**Fish and Wildlife Coordination Act Report**

**Bixby Creek Local Flood Protection Project**

Tulsa District  
U.S. Army Corps of Engineers

June 2000

Figure 2. Portion of Bixby Creek to be straightened and realigned (green), area of existing creek to be filled (blue), and mitigation areas within first mile of project (yellow).

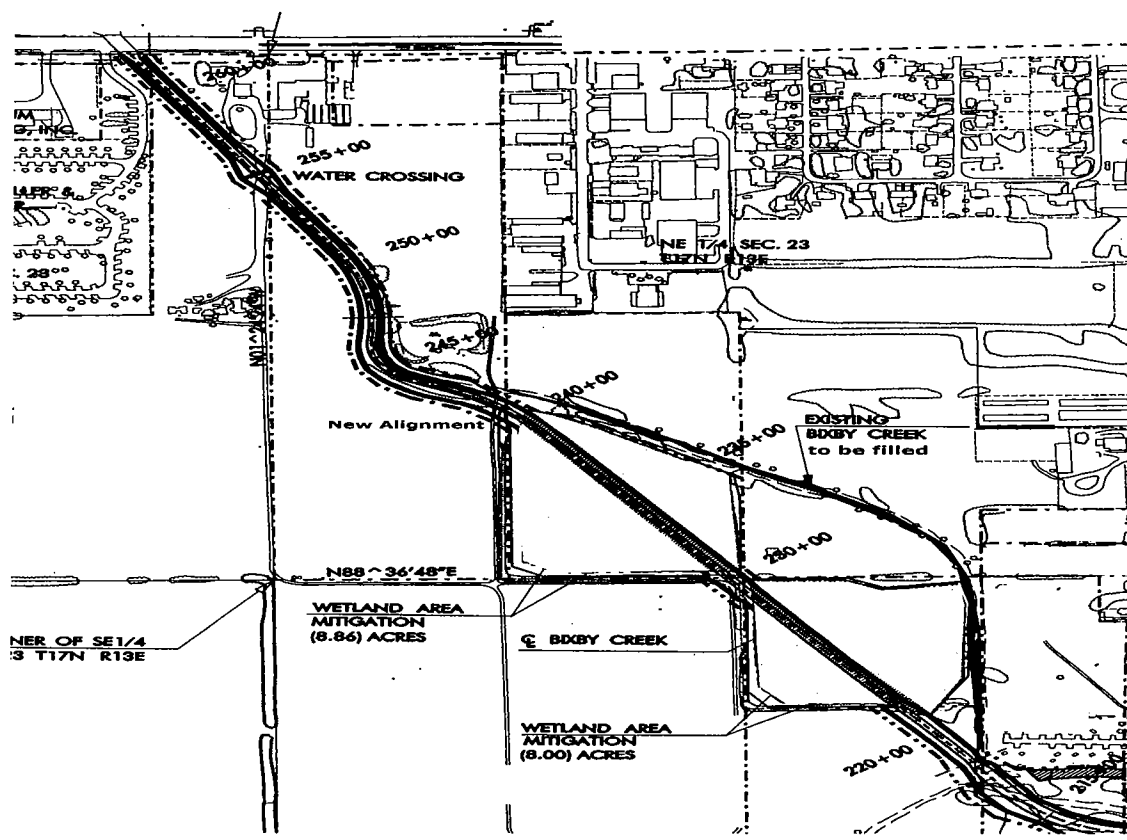
A mitigation plan for the loss of the natural stream, associated wetlands and riparian/bottomland hardwood habitat has been developed. This plan consists of creating two respective areas of excavated wetlands of 8.00 and 8.86 acres near 151<sup>st</sup> Street (Figure 1 and 2), and preserving existing off-stream wetlands contiguous to the channel (Figure 4). The Service recommends preserving these wetlands through deed restrictions, and requests the opportunity to review a detailed mitigation plan. The Service also requests that the City of Bixby contact this office about the potential for an outdoor classroom through the Service's Partners for Fish and Wildlife program for the wetland south of Bixby High School.

Figure 3. Realignment of existing channel in the lower reach near the Arkansas River (green) and location of bottomland hardwoods recommended for preservation.

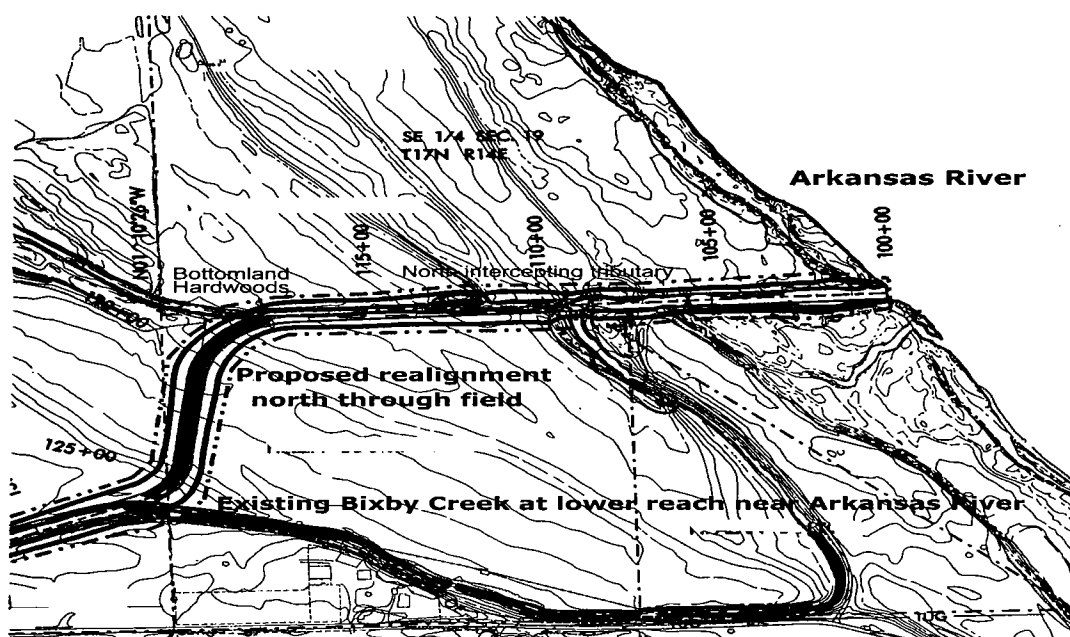
The Planning and Environmental Analysis branch of the Corps and the Service has suggested realigning a portion of the proposed channel between Memorial Drive and River View Avenue north of the existing channel to avoid the loss of a stand of bottomland hardwoods (Jerry Sturdy, Pers. Comm.). Additionally, the Service recommends planting a variety of native tree species such as hackberry, sycamore, pecan, black willow, green ash, and bur oak at the top of the channel to help improve soil strength and stability, and along the sides of each of the proposed excavated wetlands to add diversity and wildlife habitat value to the project, and preserving the mature stand of bottomland hardwoods near the proposed realignment in the lower reach (Figure 3).
